PRE-APPLICATION CONFERENCE NOTES
STEPHEN'S HILLSIDE FARM SUBDIVISION – REVISIONS (2021-033-
 PAC)

regulations at the time the original application was deemed complete July 2018. All existing structures will be removed except the residence at 208 N 348 St. will be retained on a new lot.
Meeting Date	Wednesday, November 10, 2021 at 3:00 p.m.
Date of Issue	Friday, November 19, 2021

Exhibit C Isopluvial Maps for Design Storms in Clark County

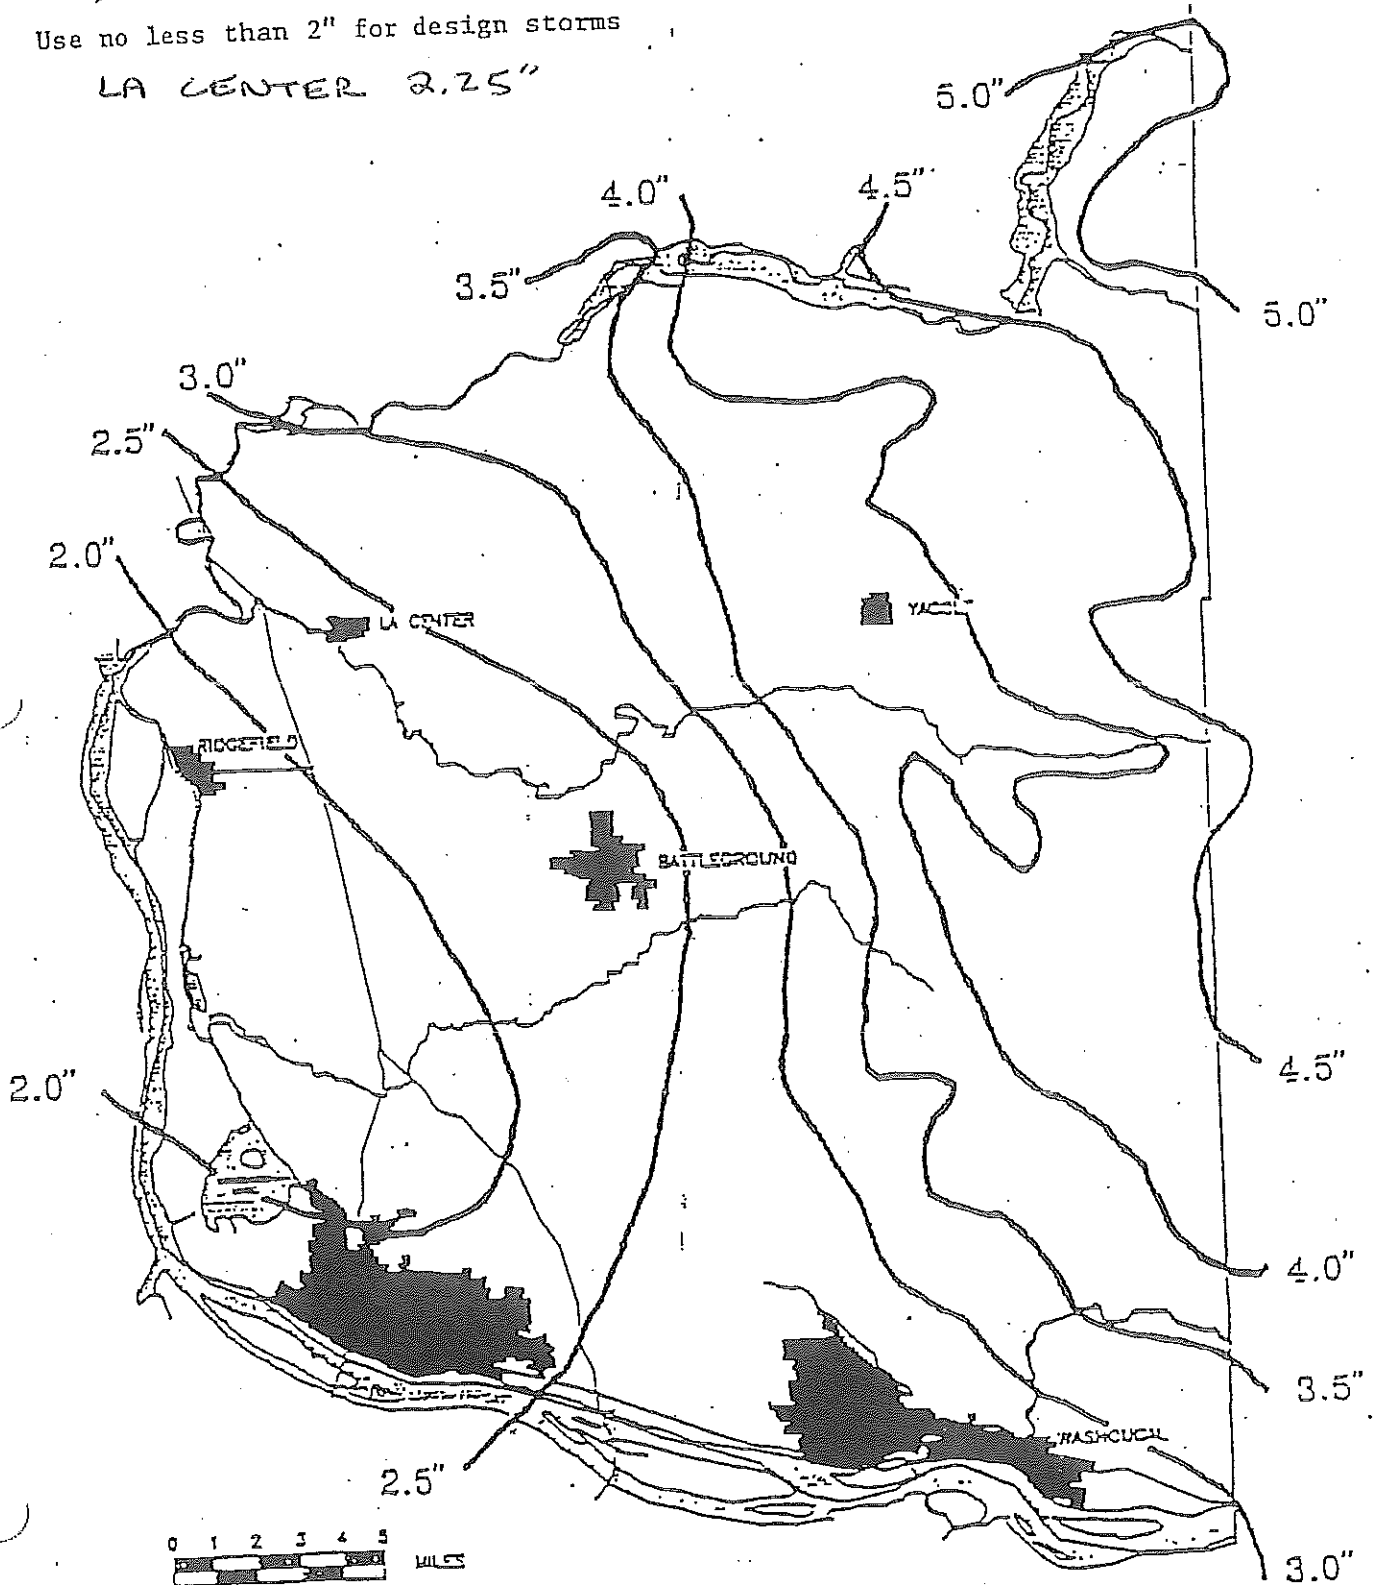
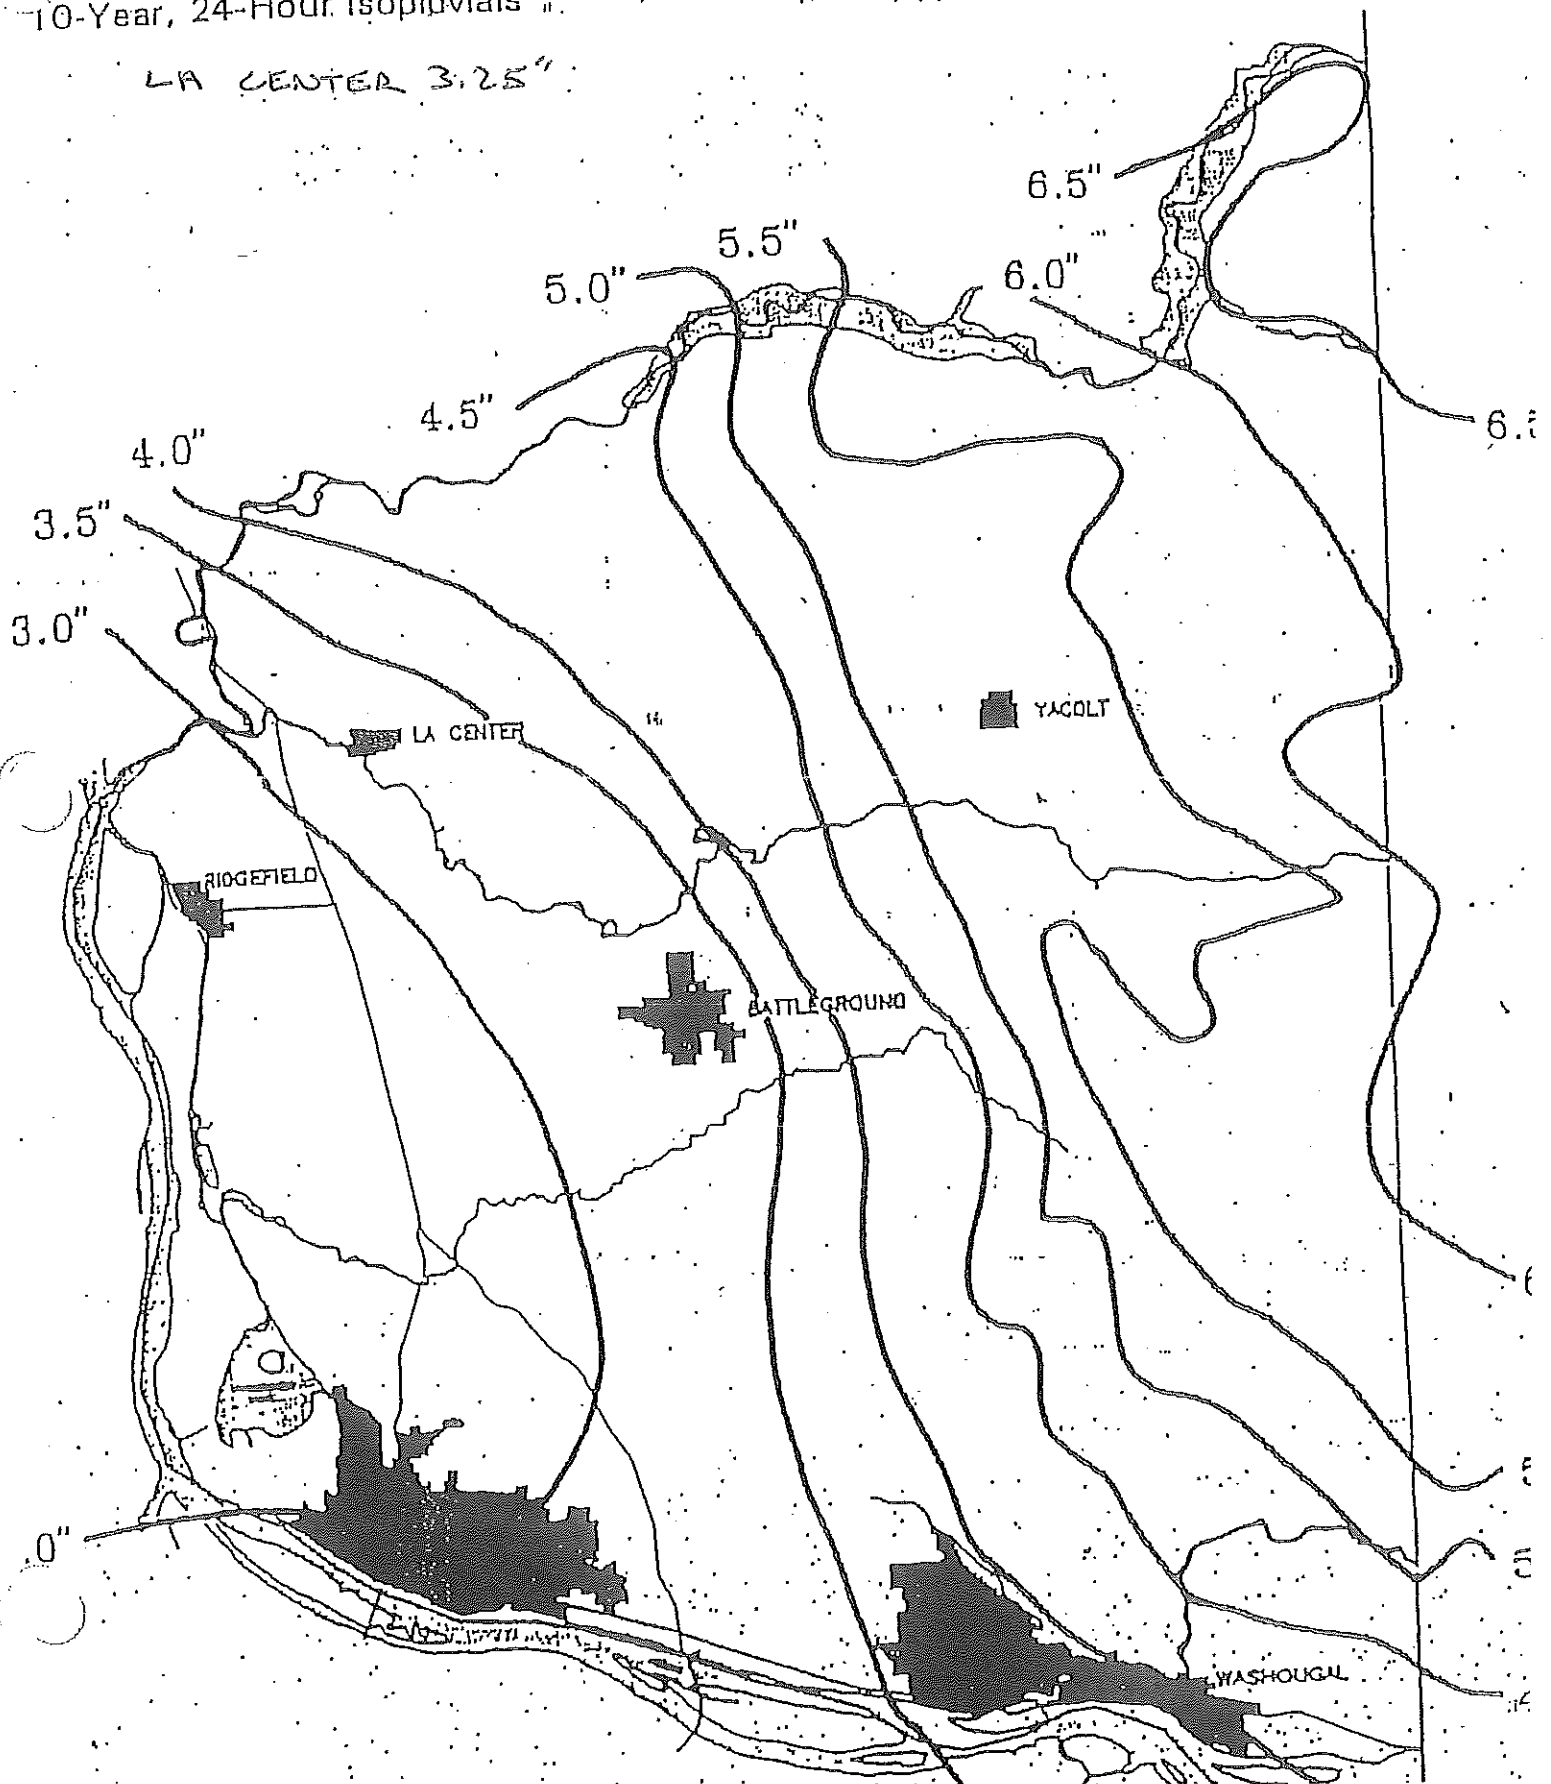
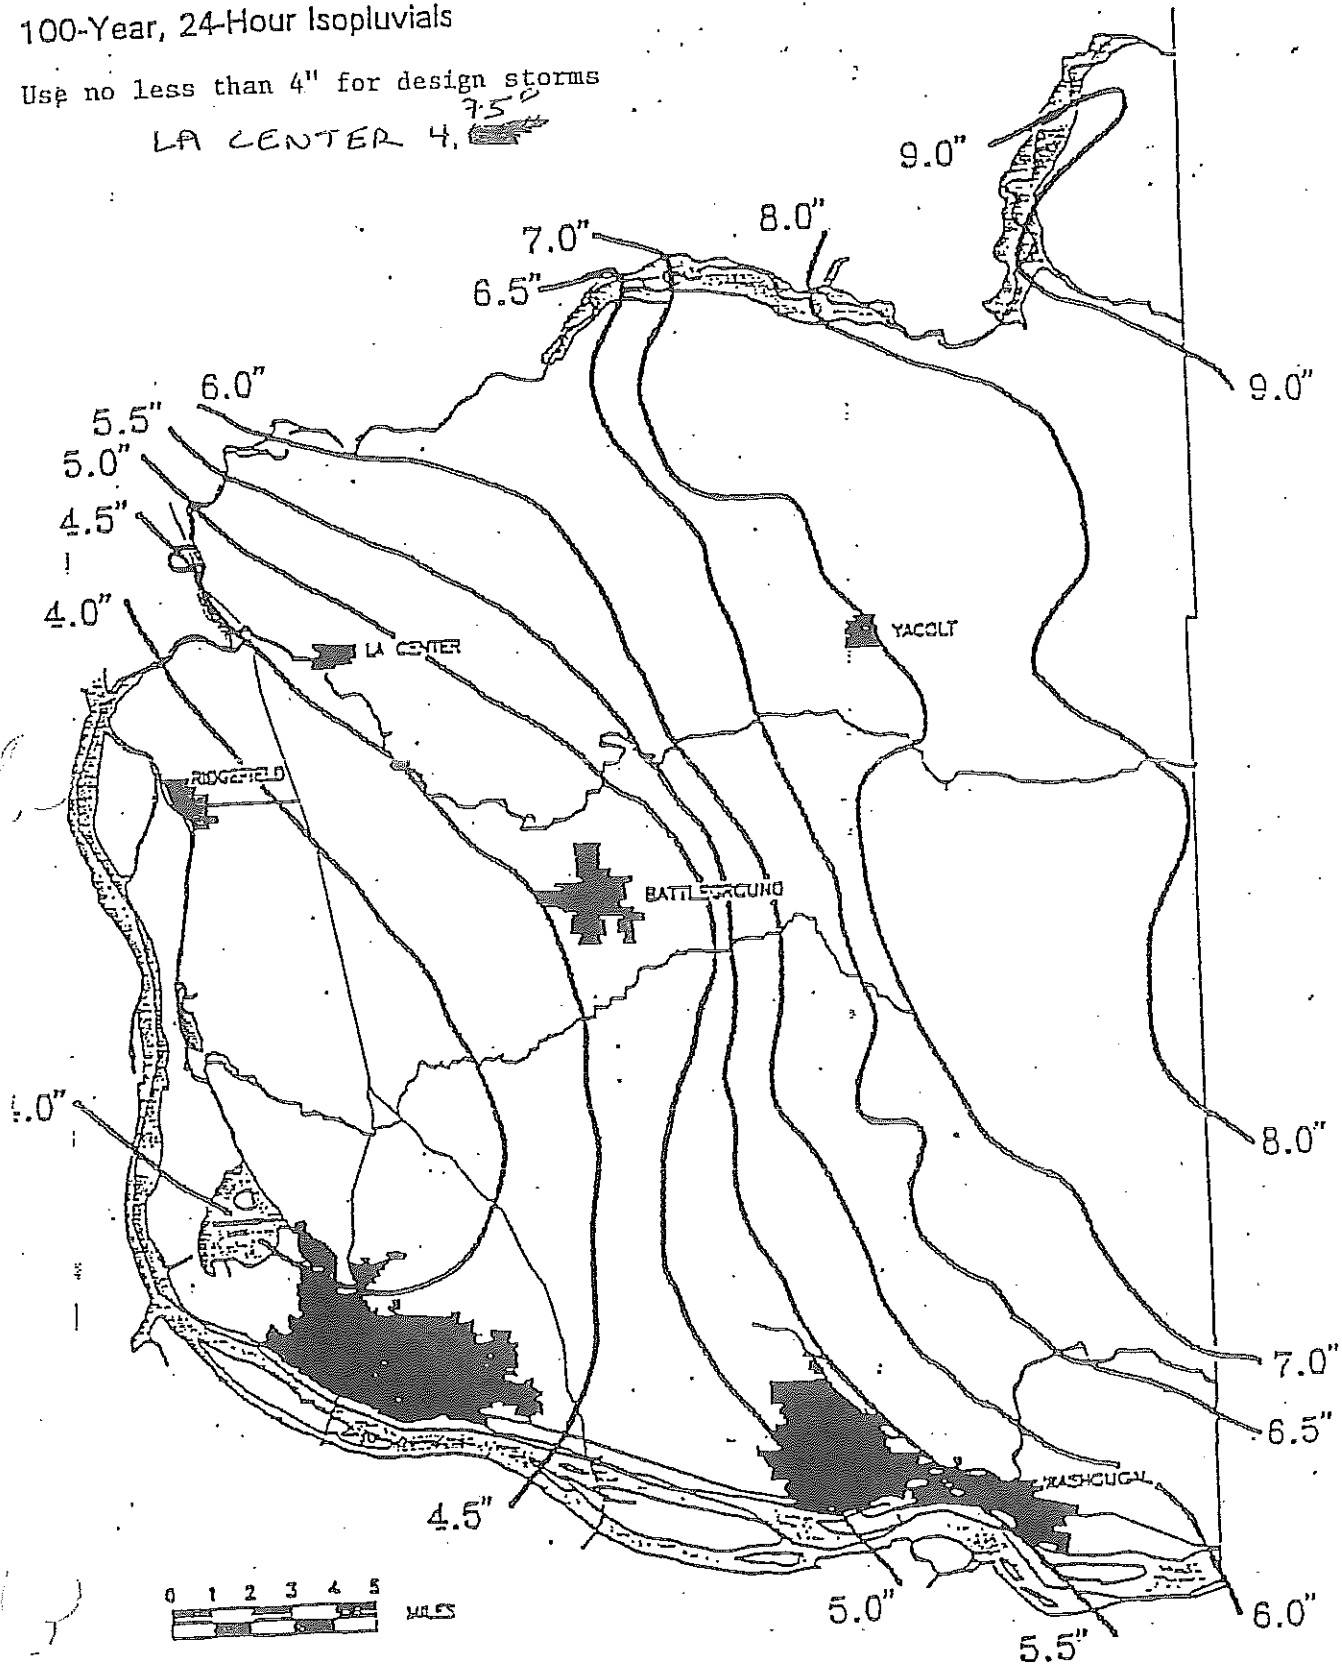
Hydraulics Manual can be used for inlet capacity design. The 100-year rainfall intensity must be used for pipe capacity design using the rational method. Attached is the City rainfall intensity chart.

TEMPORARY CUL-DE-SAC DETAIL

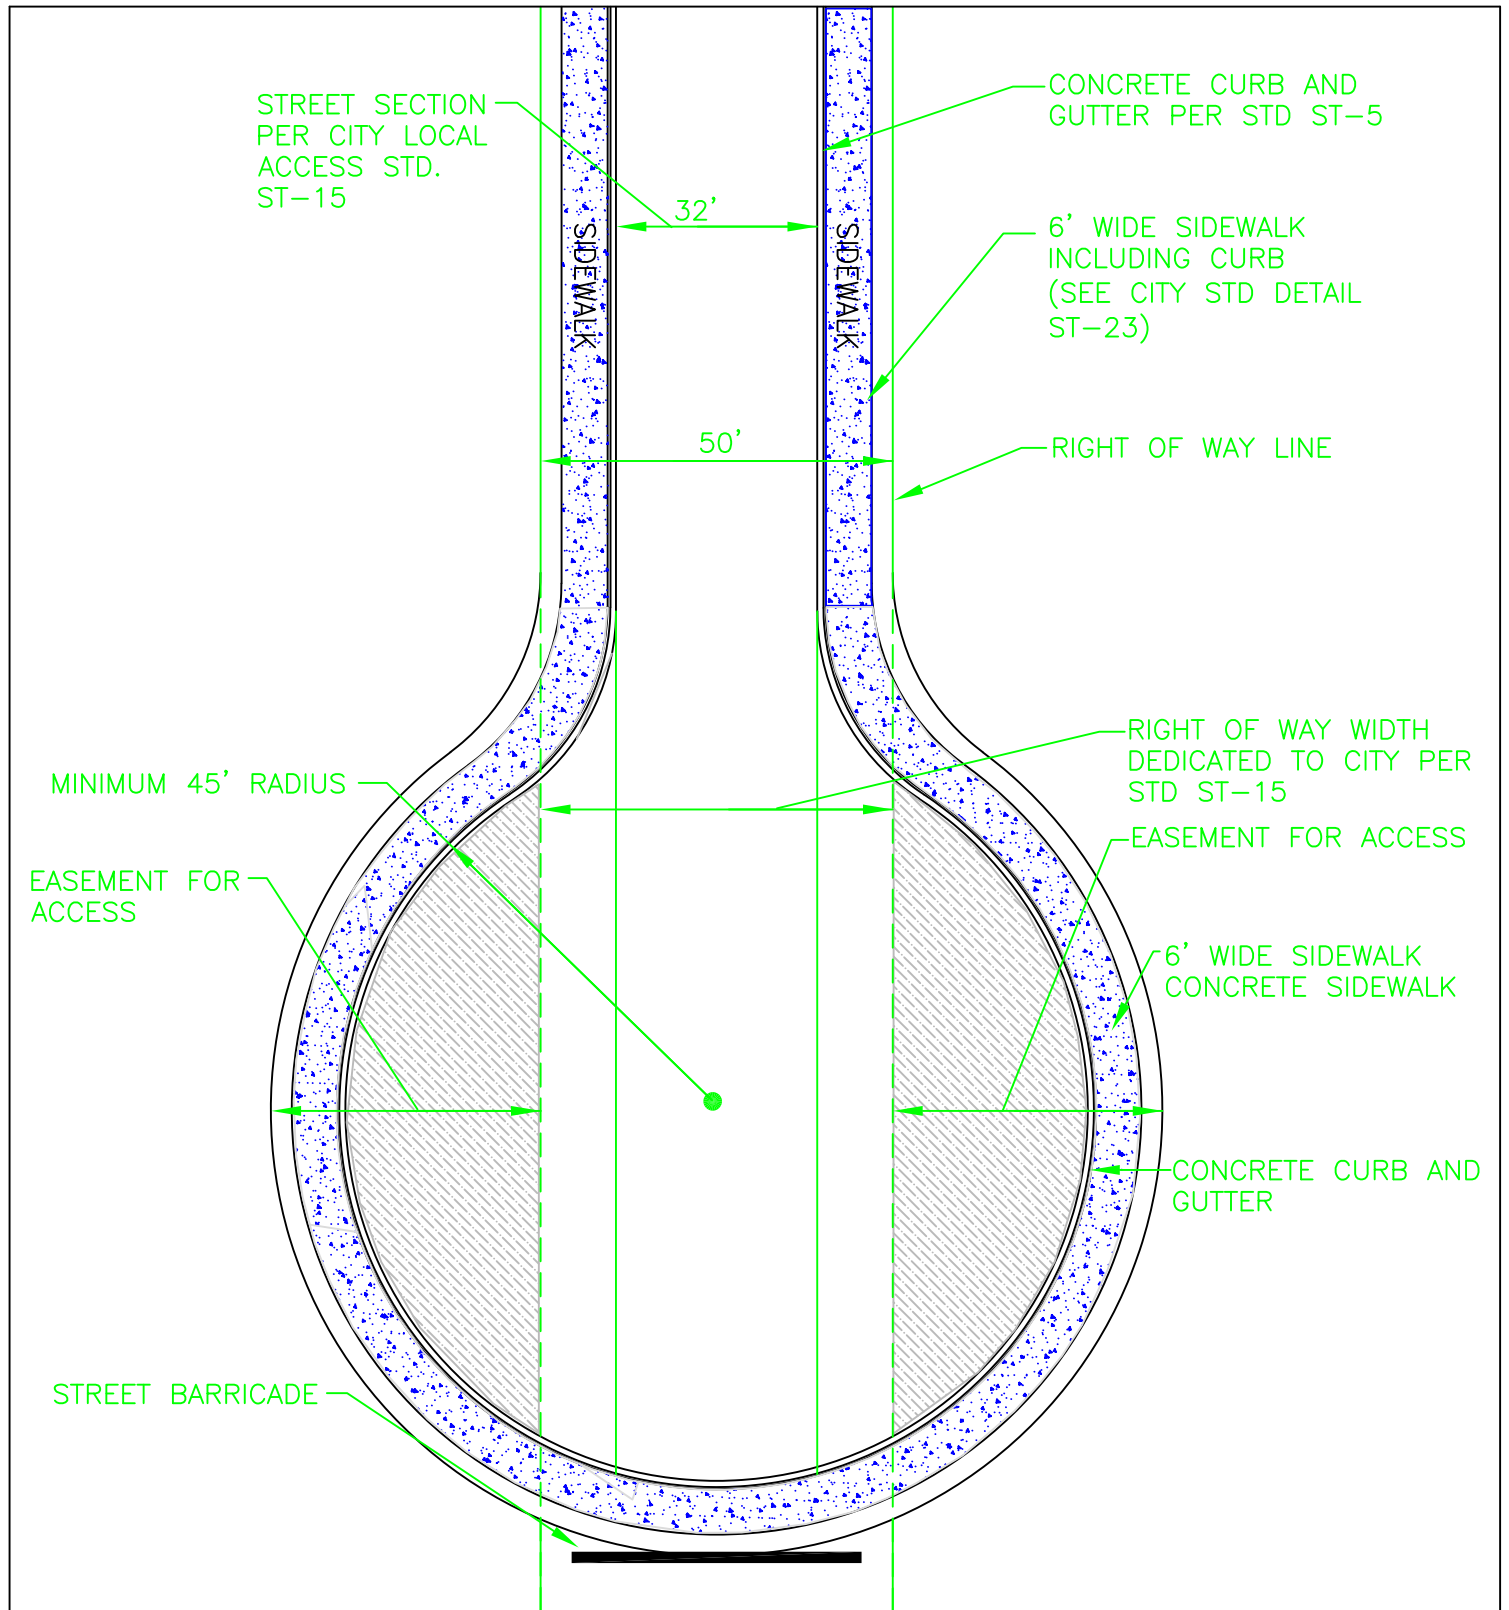
The applicant proposes to use temporary cul-de-sacs at the north termini of the street stubs to the west of the site. Section 2.12 of the Engineering Standards requires a turn-around be provided for roads serving more than one lot. The turn-around may be a hammerhead if under 200-feet and a cul-de-sac for dead end streets over 200-feet. **To provide for future extension of the street stubbed to the west, a temporary cul-de-sac may be used as long as it meets Fire Department approval for fire service.** The use of this temporary cul-de-sac will need to be reviewed by Clark Cowlitz Fire and Rescue. Attached are the City standard details of a cul-de-sac (ST-29) and offset cul-de-sac (ST-30) for design of the site. The applicant can propose another cul-de-sac design as long as it meets Fire Department approval.
